Technical Service Bulletin: tsb100283

New Exhaust Manifold Sections

This Technical Service Bulletin introduces new turbocharger section exhaust manifolds and an end section exhaust manifold on the QSK60 series engines. The manifolds have been revised to improve the durability of the system components. The two turbocharger sections have been revised to include localized wall thickening, and the end section has strengthening ribs added. New exhaust manifold mounting capscrew lock plates have also be introduced which need to be fitted to the new manifold sections when they are installed.

Figure 1

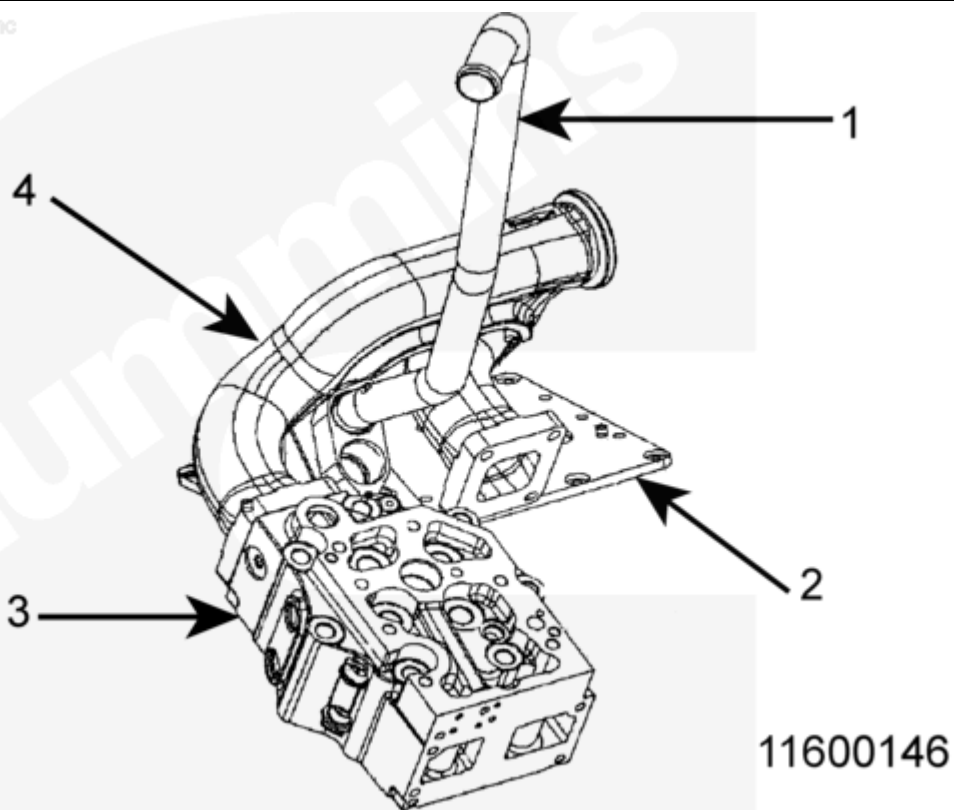
QSK60 two stage engines built after ESN 33151884 contain a rear header plate Part Number 4100953, for which the outlet ports on the plate are machined at an angle relative to the water header mounting surface on the cylinder block. When the new end section exhaust manifold is installed with this rear header plate a new intercooler water transfer tube Part Number 3635939 **must** be used to prevent a foul condition with the manifold.

If the engine is fitted with the rear header plate that does **not** have the angled outlet ports, and the new exhaust manifolds are fitted, then the water transfer tube need **not** be changed.
